# GTR9-8-03r1

## GTR9 – Draft Working Document of IG GTR9 PH2

Version 2, 10 Sept. 2013

Figure 12: Lower legform impactor (see paragraph 6.3.1.1.)

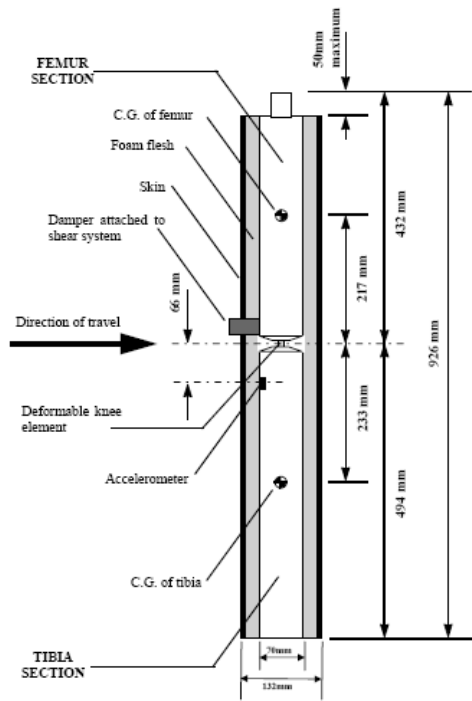
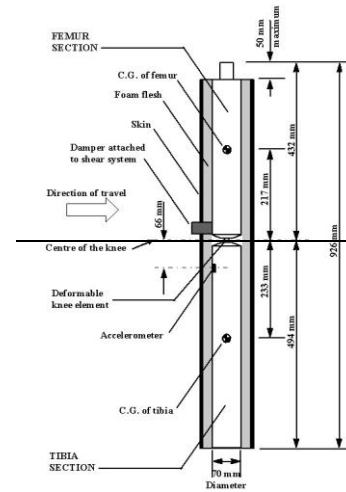
Delete Figures 12, to read:

*Delete Figures 12 :* delete figure for EEVC lower legform impactor.

**Figure 12: Flexible lower legform impactor: Dimensions and center of gravity locations of femur, knee joint and tibia (side view)**

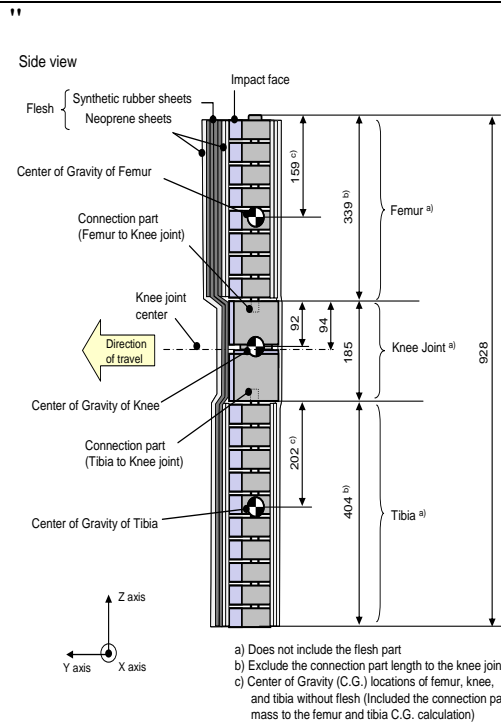
**Kommentiert [TK3]:** OICA proposes that all tolerances for the length should be covered by figure 12 and taken off this paragraph to improve readability.

**Kommentiert [TK9]:** See above: Figure should contain the respective tolerances.

**Figure 13: Flexible lower legform impactor: schematic plan views of femur, tibia, and knee dimensions (top view)**

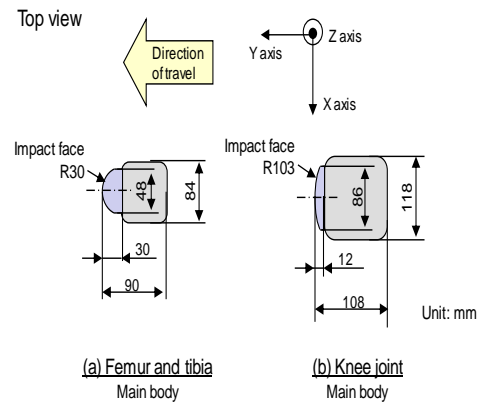
**Kommentiert [TK5]:** Proposal of OICA to add tolerances to figure 13 (a), delete the whole paragraph and say “The cross sectional shape of the femur and the tibia main body segments shall be as defined in figure 13 (a).”

**Kommentiert [TK10]:** See above: Figure should contain the respective tolerances.

**(a) Synthetic rubber sheets**

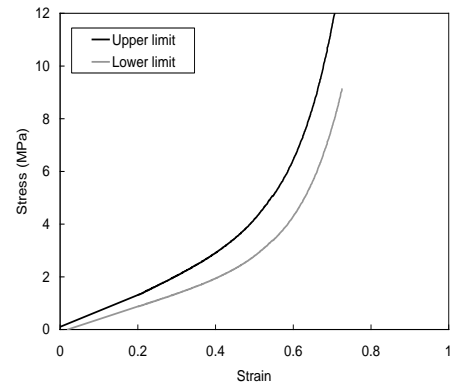
Kommentiert [TK11]: Humanetics noted that the skin tolerance changes from 5 to 5.6 mm; this needs to be reflected in this figure.

**Figure 15: Flexible lower legform impactor: flesh and skin compression characteristics**

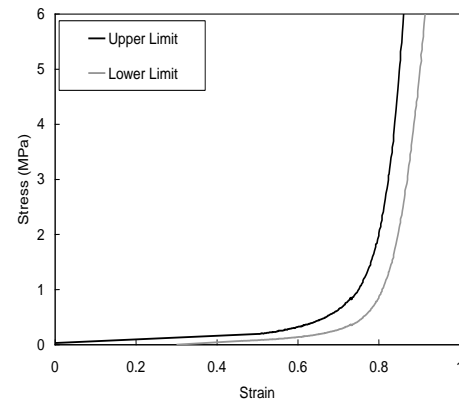
**Kommentiert [TK12]:** Humanetics will change this diagram to address the changes to the neoprene skin.

Figure 47 21: **Flexible lower legform impactor** Lower legform to bumper tests for complete vehicle in normal ride attitude (left) and for cut-body mounted on supports (right) (see paragraph 7.1.1.3.) "

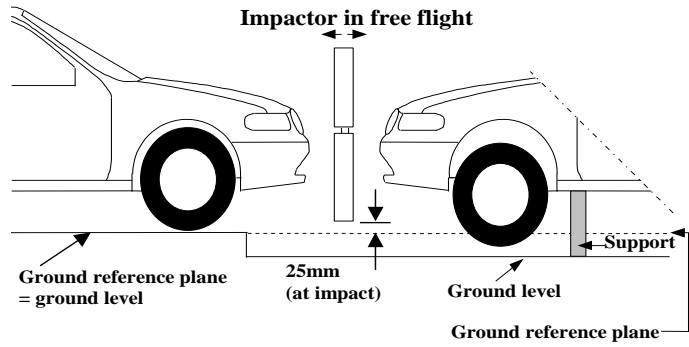
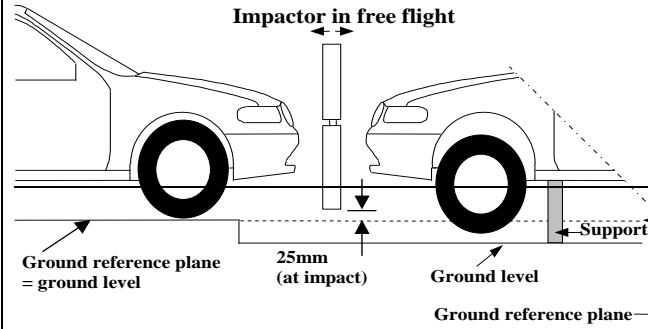
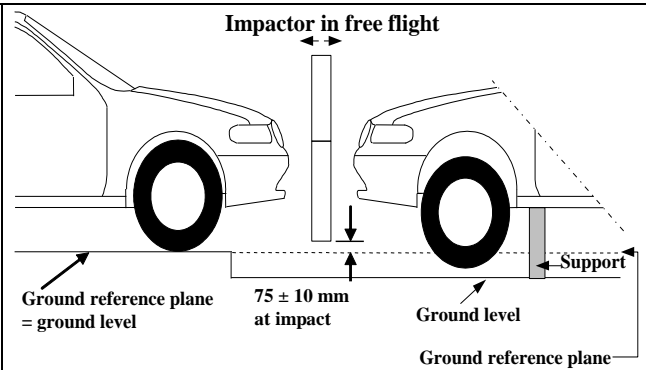
Figures 17(former), renumber as Figure 21 and amend to read:

*Figure 17 (former):* renumbering and replaced by flexible lower legform impactor requirements.

**Figure 28:** Flexible lower legform impactor: Test set-up for the dynamic lower legform impactor certification test (inverse test, see paragraph 8.1.3.4.)

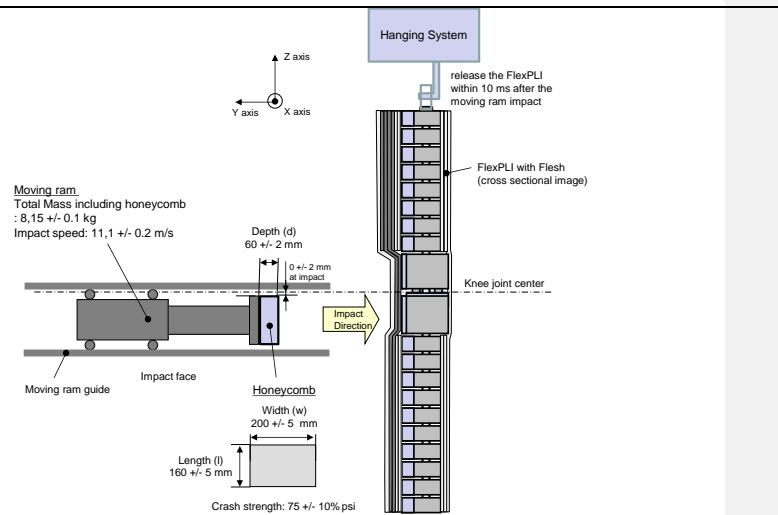
**Kommentiert [TK14]:** The figure needs to say „FlexPLI with flesh and skin“ for the impactor. For the honeycomb cell, it should say “width” and “height” and needs to mention the paper cover (max. 1 mm thick).
